DN-166.1*
EN-57.1*
FN-45.1*

SERVICE BULLETIN

SUBJECT: One-time Inspection and Replacement of **Air Industries** MS21250-04036 Bolts **AND** Verification of Proper Installation of All MS21250-04036 Bolts in Main Transmission.

MODELS AFFECTED: All McDonnell Douglas Helicopter Company (MDHC) 369D, 369E (Serial No. 0001E thru 0352E) and 369F/FF (Serial No. 0001F thru 0067FF) Series helicopters.

Figure 1. Inspection/Replacement of Main Transmission Output Driveshaft Bearing Assembly Bolts

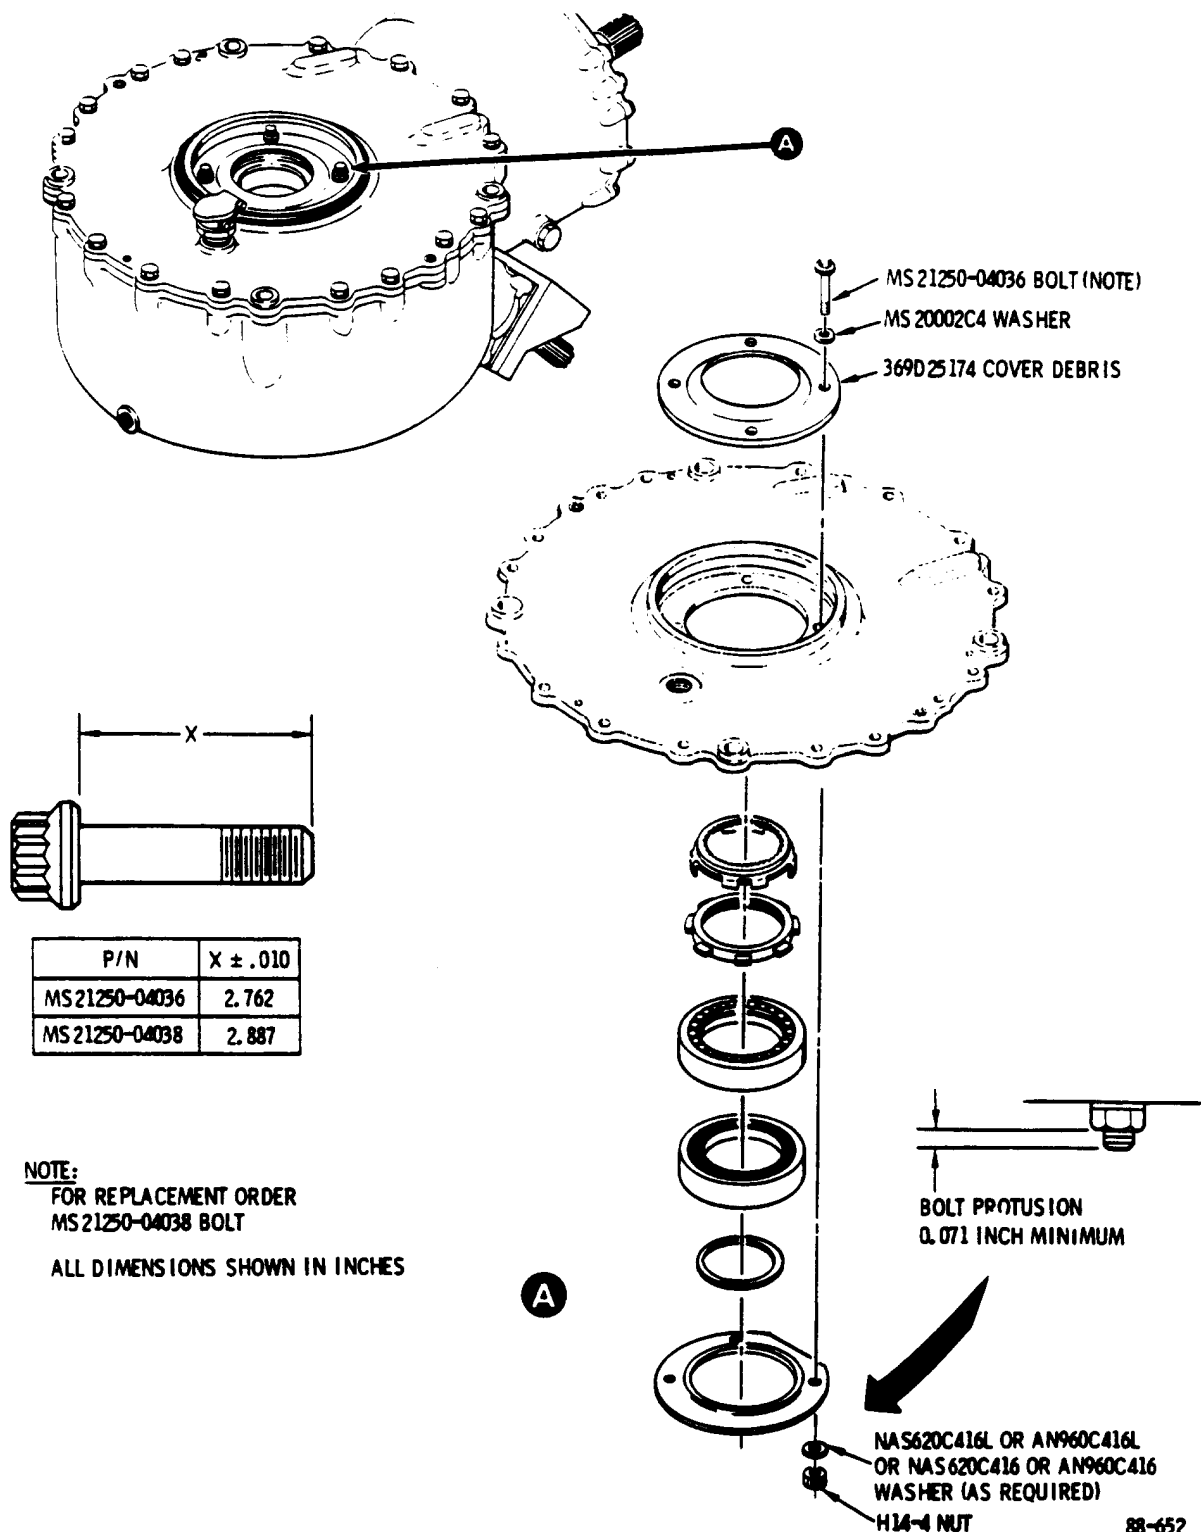
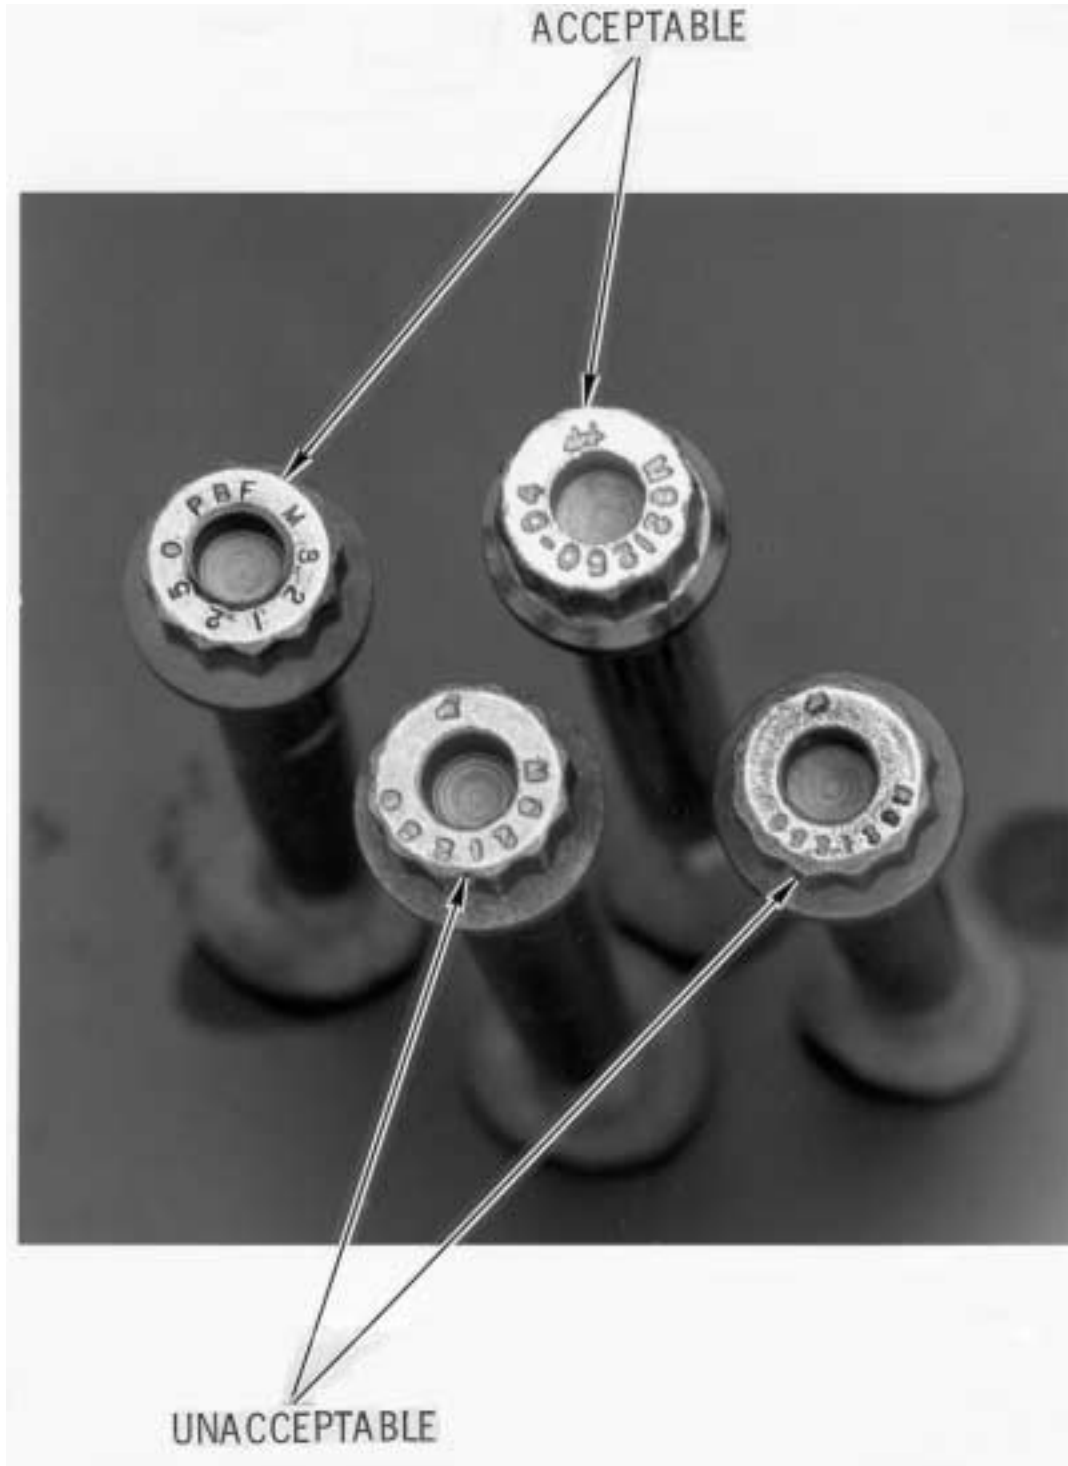
- d. Inspect bolts for proper thread protrusion through the H14-4 nuts. If proper thread protrusion cannot be obtained, replace bolts with MS21250-04038 bolts.

- Bolts must protrude through the nut for a length equivalent to two full threads (0.071 inch minimum), including the chamfer. Thread protrusion must not exceed four (4) threads. The H14-4 nut may be installed without a washer.
- To prevent possible dislocation of clamp-up shims on main rotor output drive assembly, remove unacceptable bolts individually.

- e. Install acceptable MS21250-04038 bolts, washers and nuts (Ref. CSP-DEF-5). Torque bolts **50-70 inch-pounds**. Verify that bolts protrude through the nut for a length equivalent to two full threads (0.071 inch minimum), including the chamfer. If more than 4 threads protrude through the nut, add NAS620C416L or NAS620C416 (or acceptable alternate per Parts List) washer(s) under the nut as required.
